ARCHITECTURAL SUPPLEMENTAL INSTRUCTION:
ALL TERAZZO INSERT DIMENSIONS (TOTAL WD & HGT) ARE 1/4" MODULAR TO FIT WITHOUT
IRREGULAR OR ADDITIONAL TILE CUT INTO 1/4"X28" FLOOR TILE PATTERN.
TERAZZO AND TILE CONTRACTOR ARE REQUIRED TO COORDINATE AND
CONFIRM FINAL SIZE AND PLACEMENT OF TERAZZO ART INSERTS.

**ST PETE CLEARWATER AIRPORT
INTERIOR TILE PROJECT**
(IN ADDITION TO CORRIDOR TILE PROJECT)

Drawing Name:
**FLOOR PLAN
TERAZZO DETAIL**

Drawing Number:
I.1.10

02 TERAZZO DETAIL
1" = 1'-0"

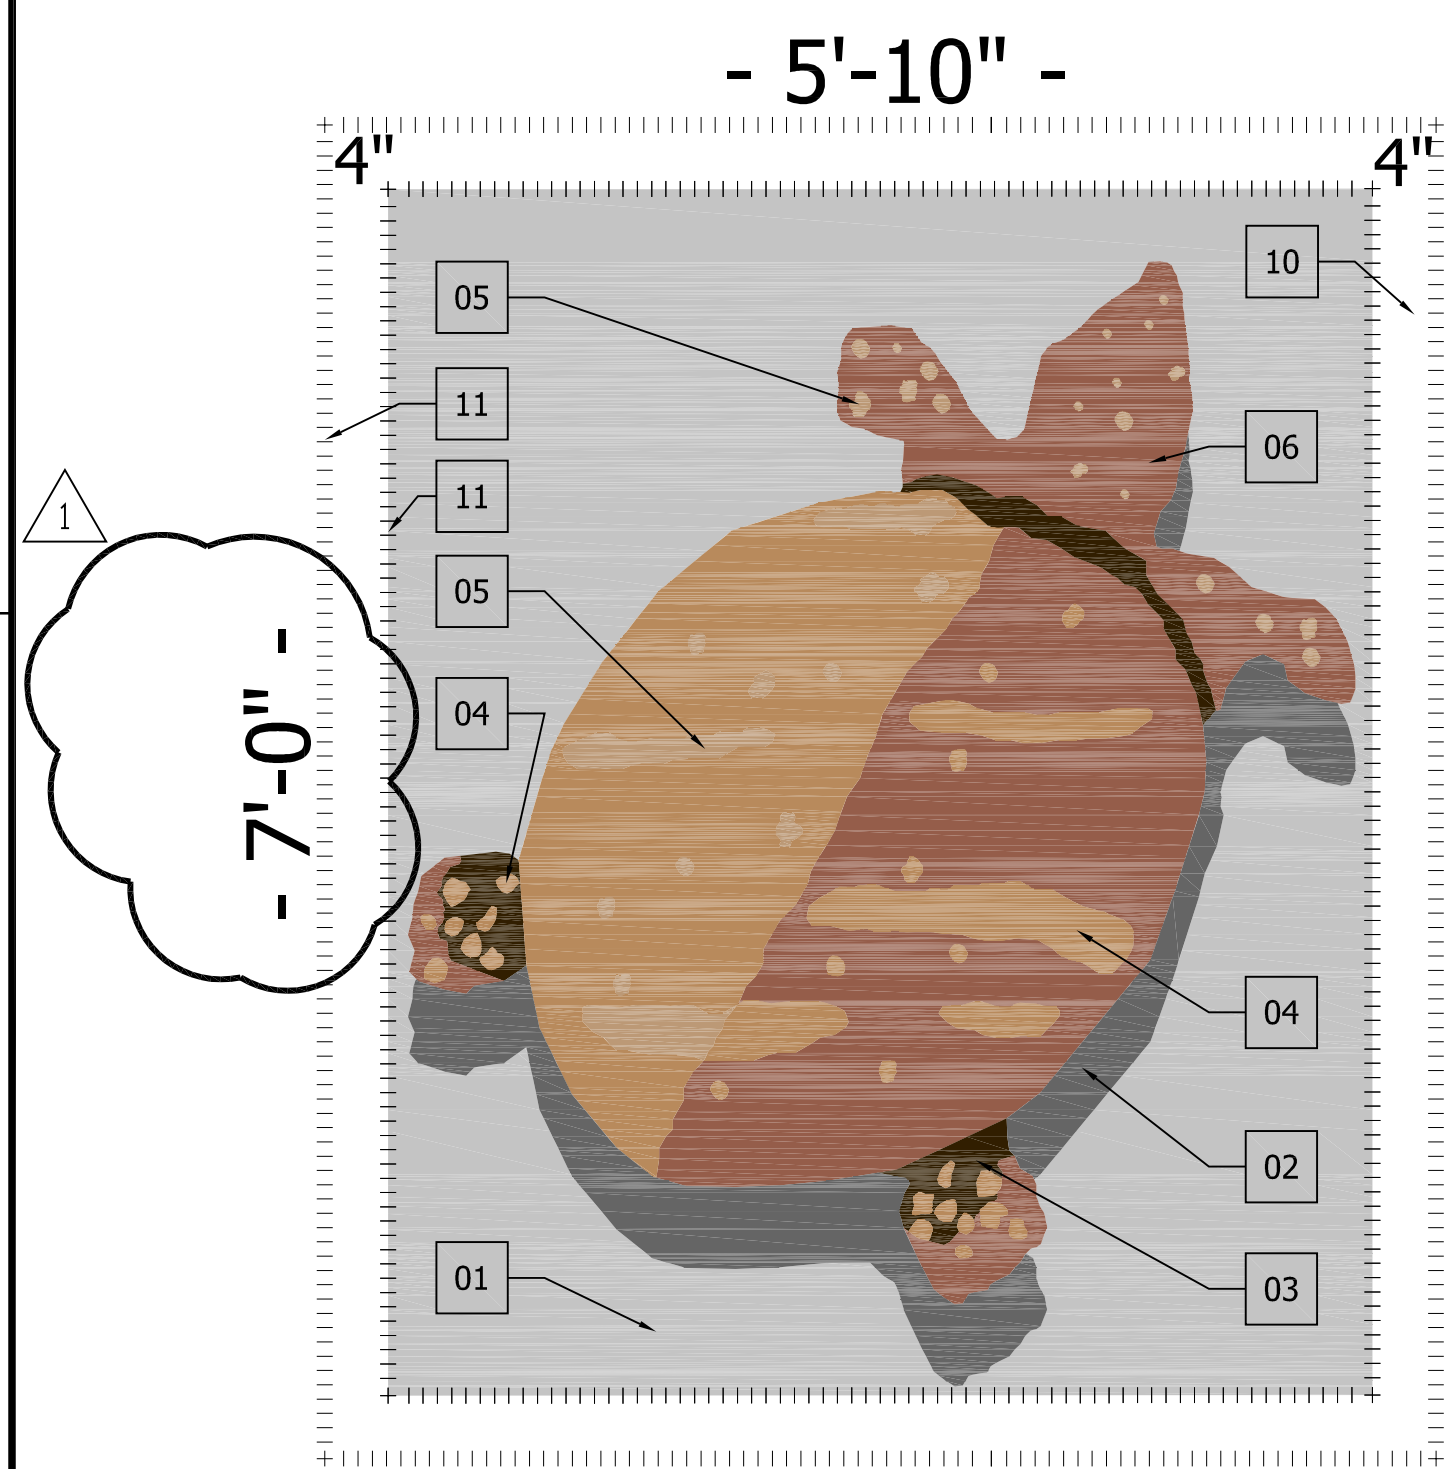
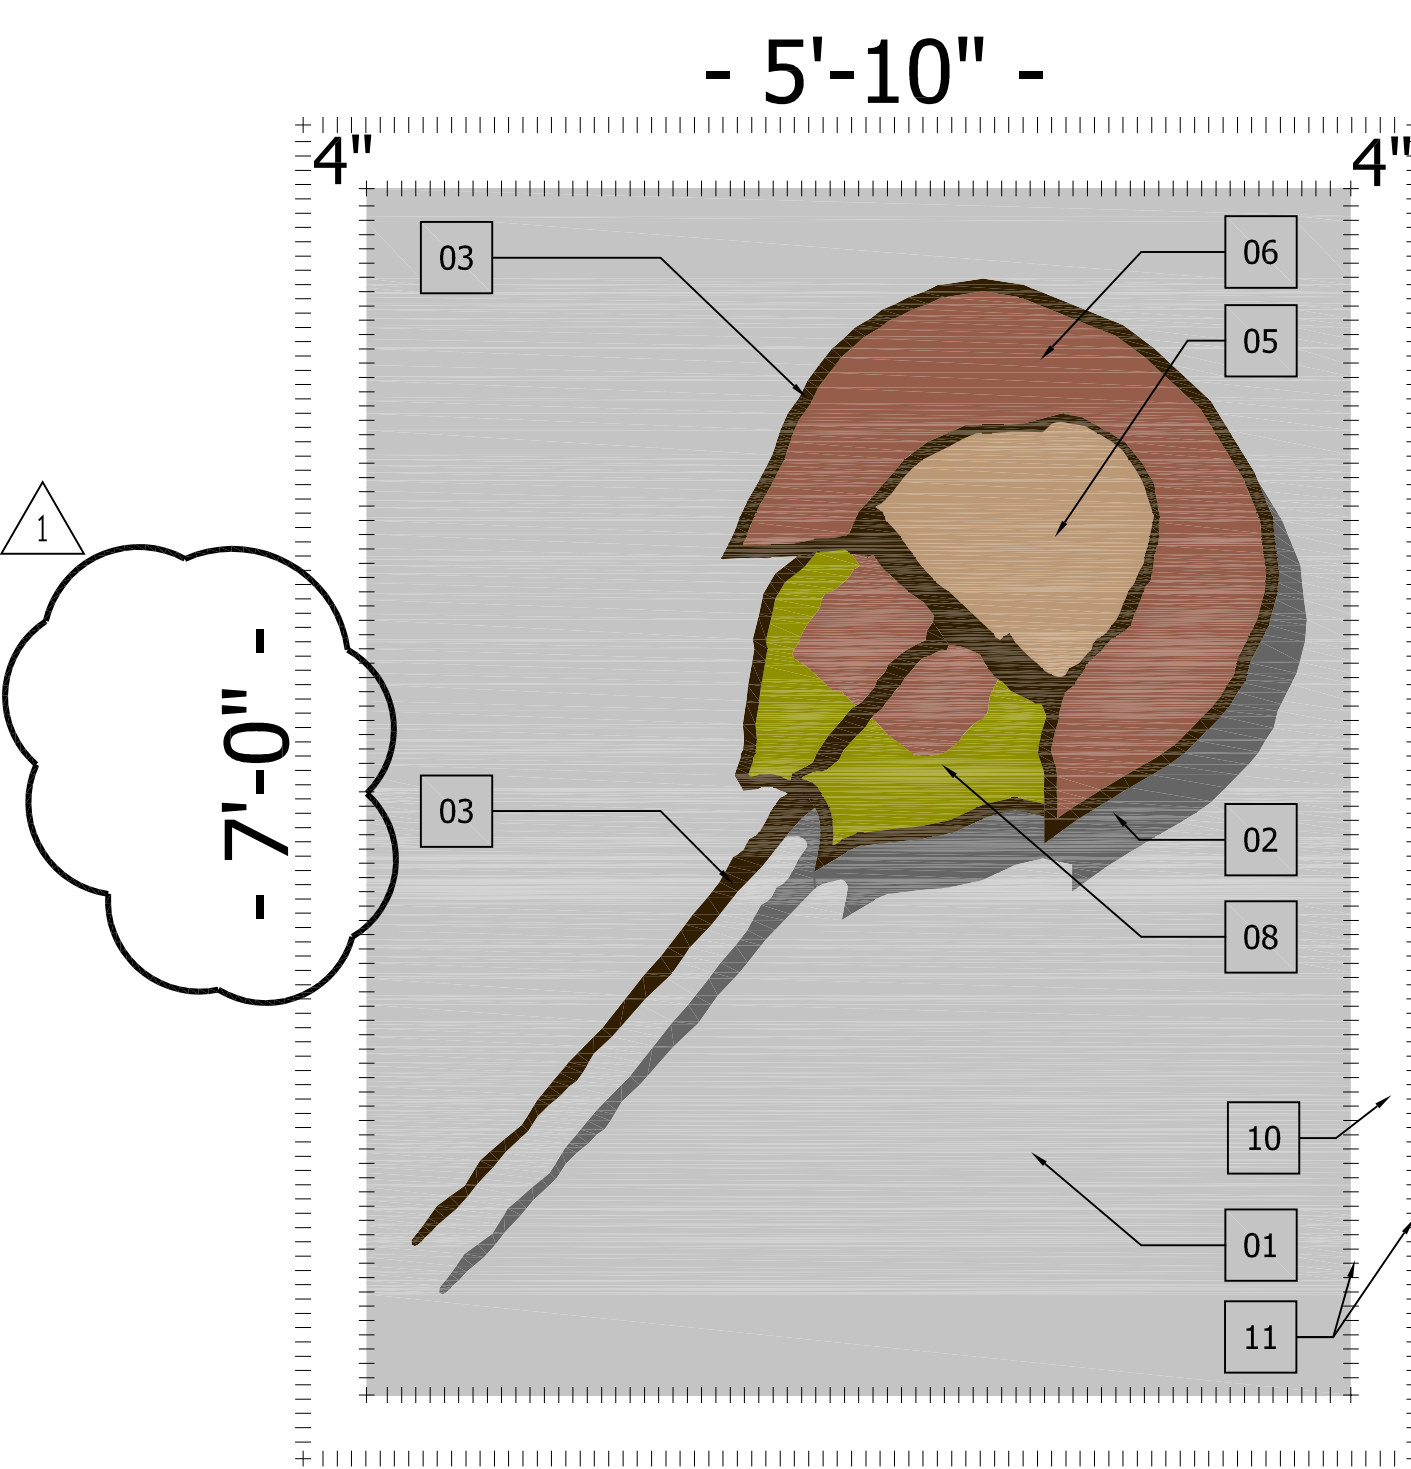
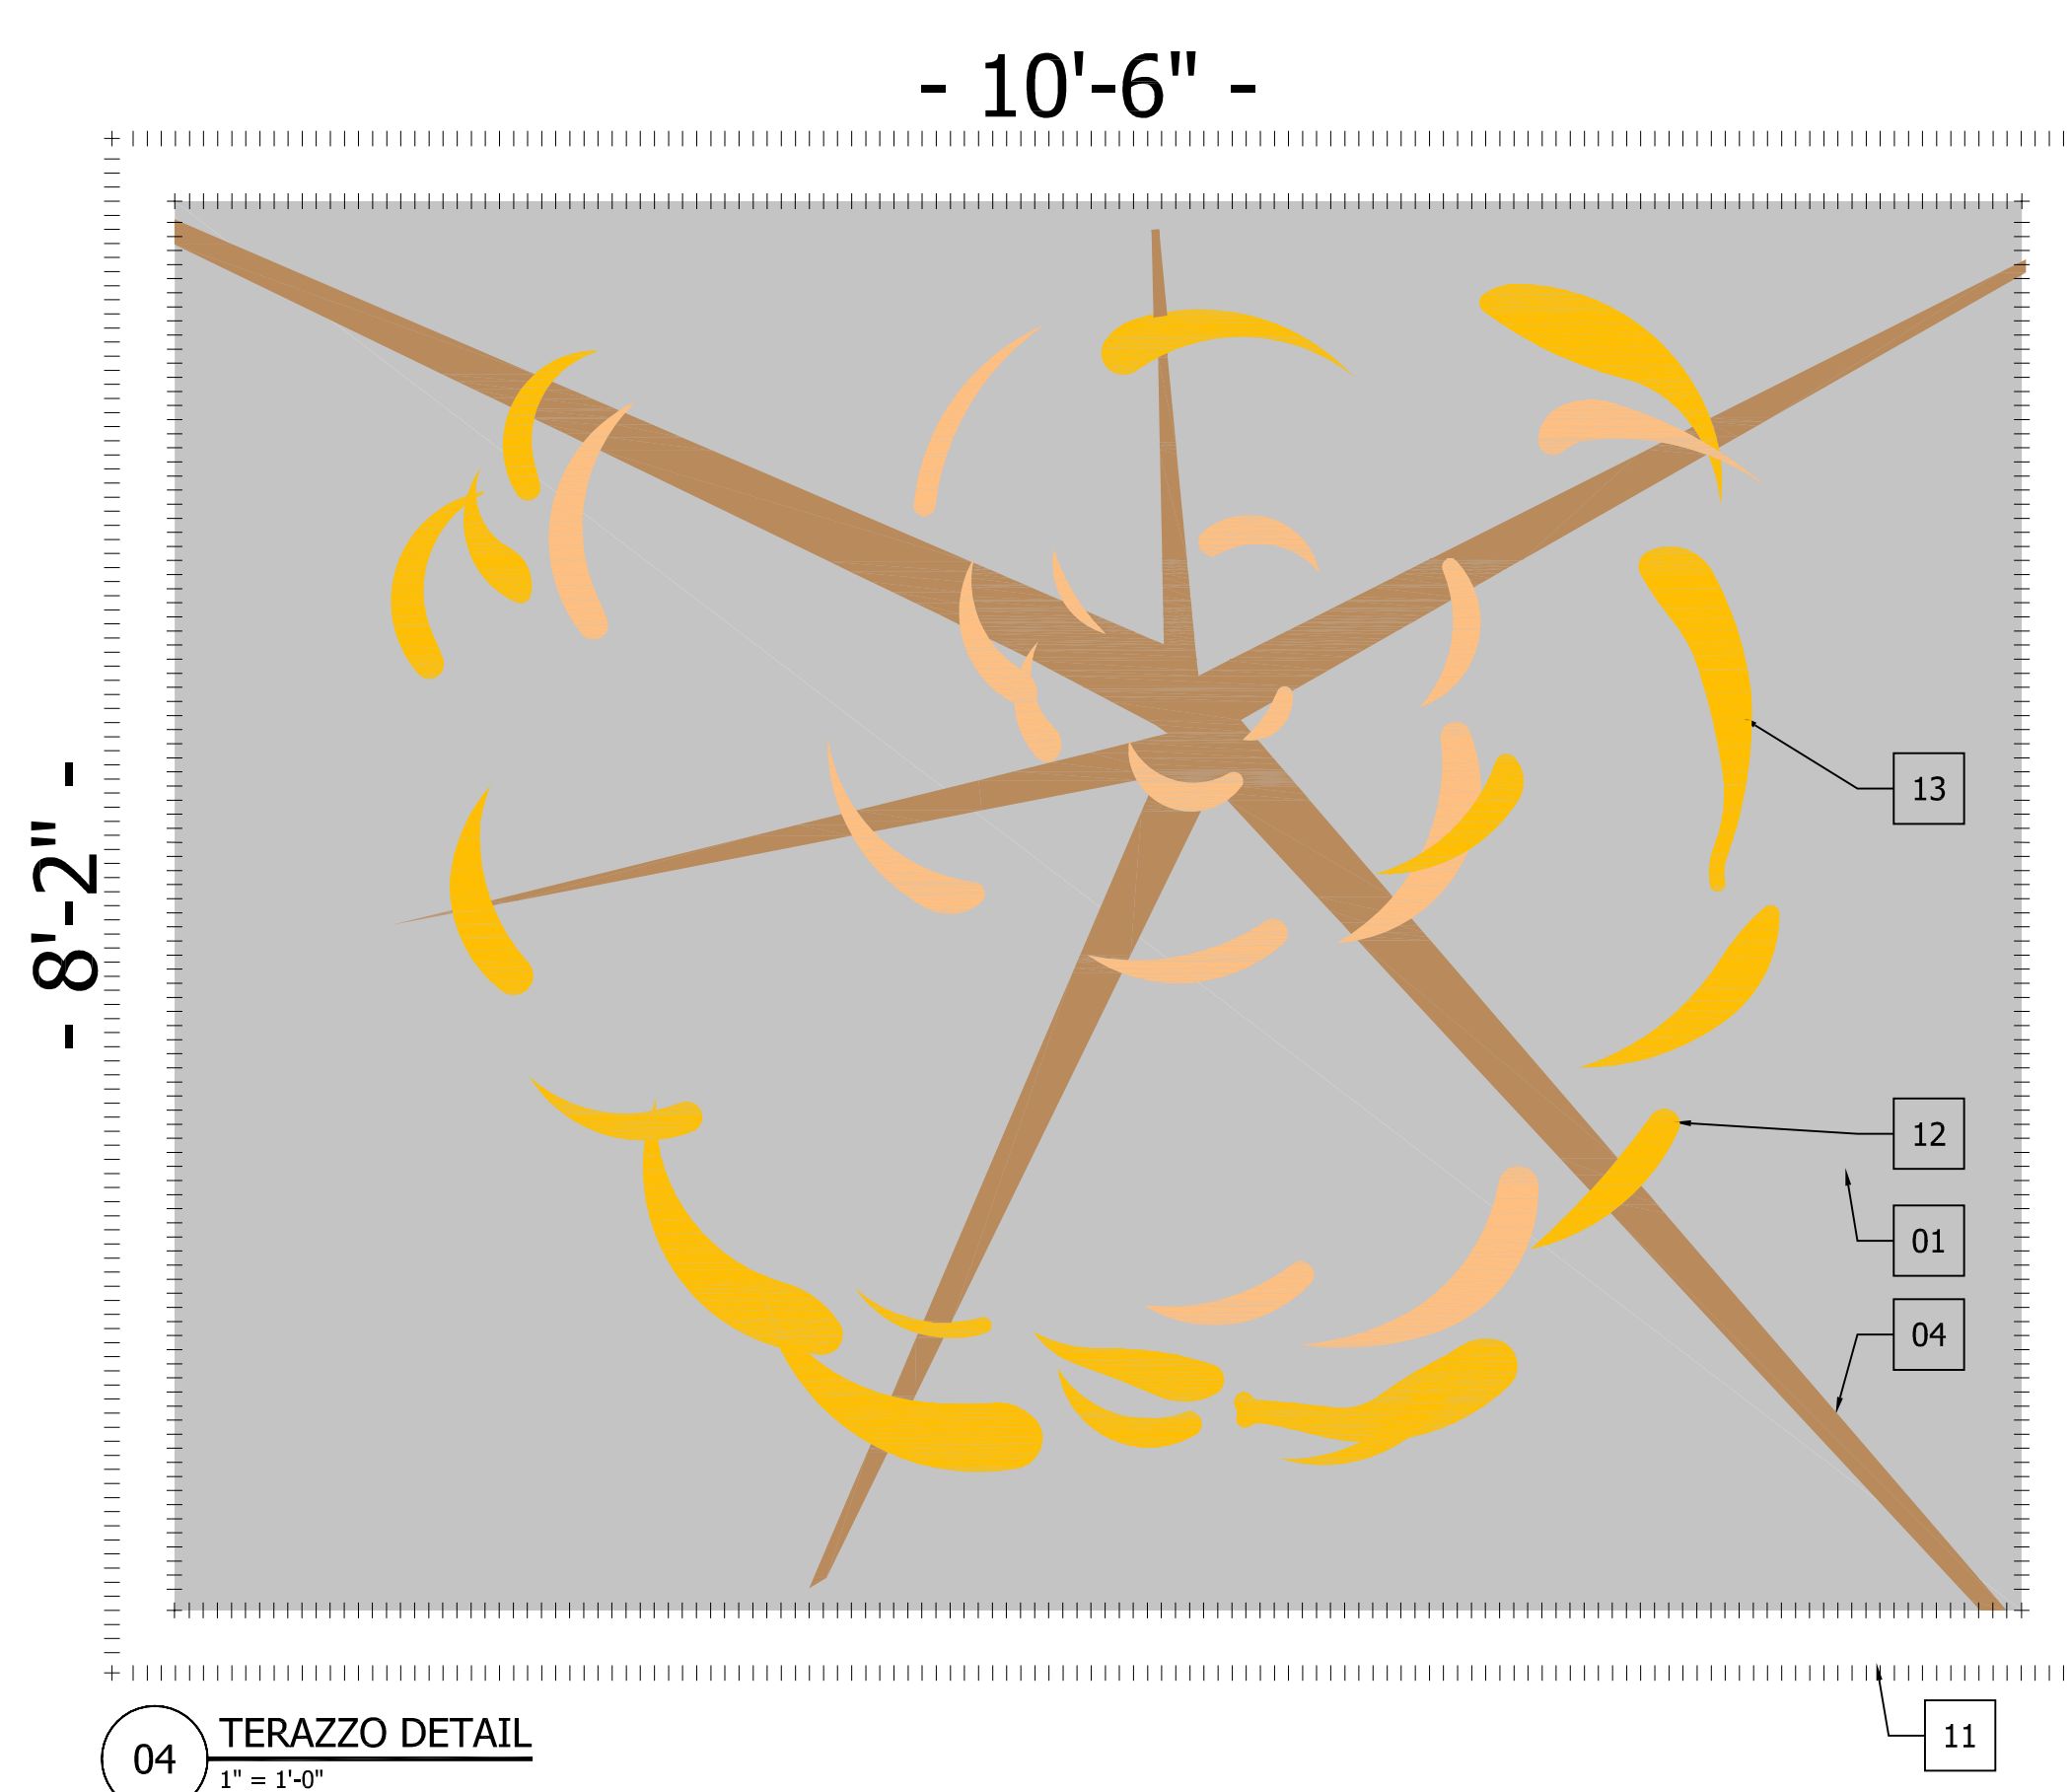
| No. | Description | Date | By |
|-----|------------------------------|----------|----|
| 1 | ASH: CORRECTION OF TOTAL HGT | 07.06.09 | SB |
